RESPONSE TO REQUEST FOR ADDITIONAL INFORMATION

APR1400 Design Certification

Docket No. 52-046

RAI No.: 509-8591
SRP Section: 16 - Technical Specifications
Application Section: TS Section 3.6
Date of RAI Issue: 08/01/2016

3.6.3 Containment Isolation Valves

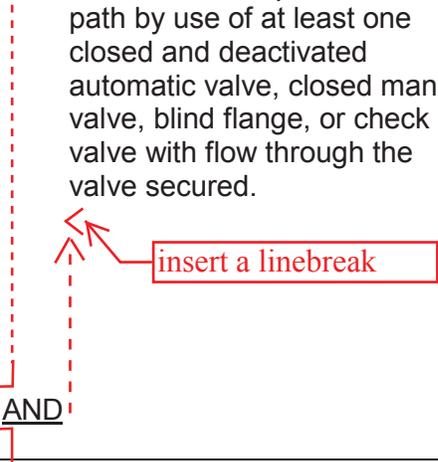
- On page 3.6.3-1, the Logical Connector "AND" is not formatted correctly. It should appear flush left directly below the text in Required Action A.1, separated by a line break.
- On page 3.6.3-2, insert a line break between the bottom single line of the NOTE and the text of Required Action A.2. Ensure the corresponding text in the Completion Time column is lowered to align with the text in the Required Action column.

The editorial items described for Technical Specification S 3.6.3 will be replaced as indicated in Attachment.

Technical Specification Subsection 3.6.3, pages 3.6.3-1, 3.6.3-2 and 3.6.3-3, will be revised as indicated in Attachment.
